Executive Director's Recommendation

PROJECT Metropolitan Branch Trail Extension Fort Totten Metrorail Station Washington, DC	NCPC FILE NUMBER 7861
SUBMITTED BY United States Department of the Interior National Park Service and the District Department of Transportation	NCPC MAP FILE NUMBER 10.12(70.00)44506
REVIEW AUTHORITY Federal Projects in the District per 40 U.S.C. § 8722(b)(1) and (d) District Projects Outside the Central Area per 40 U.S.C. § 8722(b)(1)	APPLICANT'S REQUEST Approval of comments on concept design
	PROPOSED ACTION Approve comments on concept design
	ACTION ITEM TYPE Consent Calendar

Metropolitan Branch Trail Extension

Concept Review

VINE PLANTING ALONG WALL DETAIL

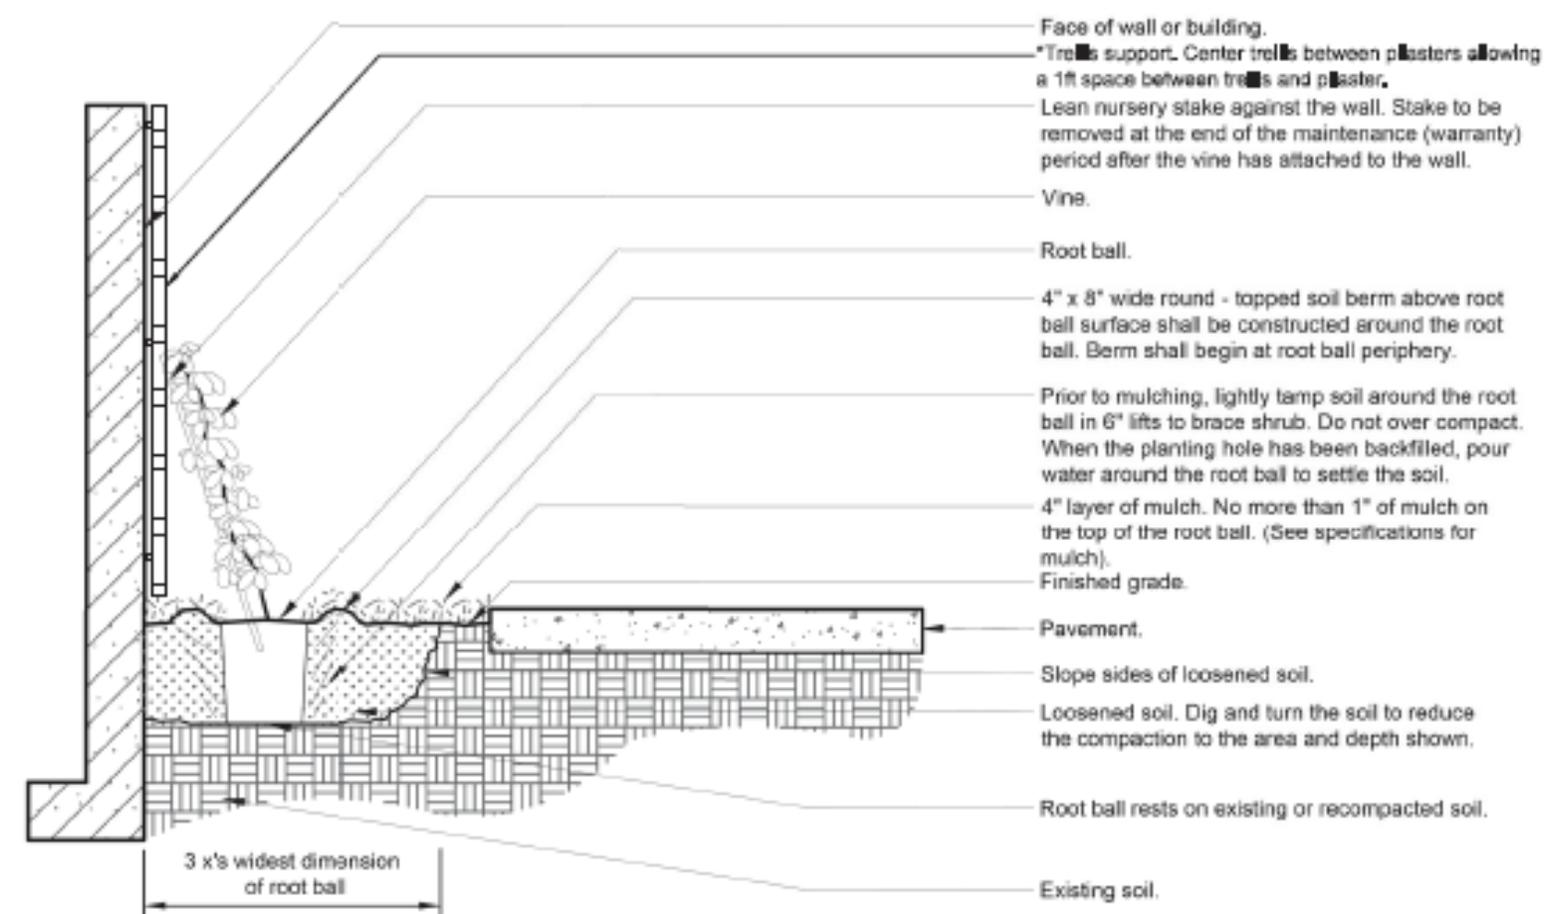
Requests the applicant agencies provide additional information regarding the proposed retaining walls, including their height, materials, façade texture and pattern, along with renderings, at the time of preliminary review.
